ENGINEERING PRACTICE STUDY

TITLE: LEAD REQUIREMENTS FOR MIL-PRF-49470

PROJECT NUMBER 5910-2014-013

FINAL REPORT

Coplanarity

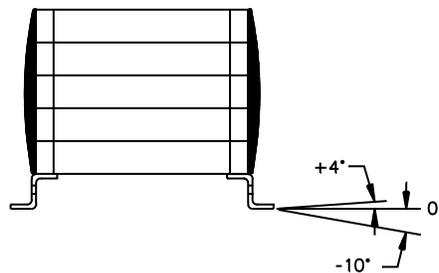
This proposed coplanarity requirement is intended for lead styles “L” and “J” to ensure that the lead bends are in one plane. The maximum deviation limit of .003 inches originates from [NASA STD 8739.2](#) (Workmanship Standard for Surface Mount Technology) (canceled).

Foot Angle

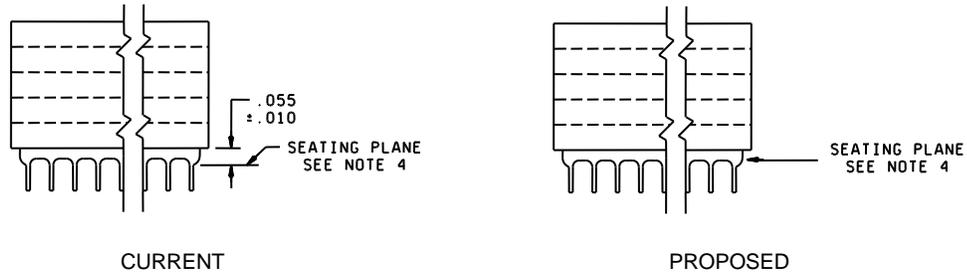
This proposed foot angle requirement is also intended for lead styles “L” and “J” to ensure that the lead bends are horizontal. A maximum deviation of +4°, -10° was suggested by a manufacturer.

1. Foot angle shall be +4°, -10° from the plane formed by the bottom of the chip stack.
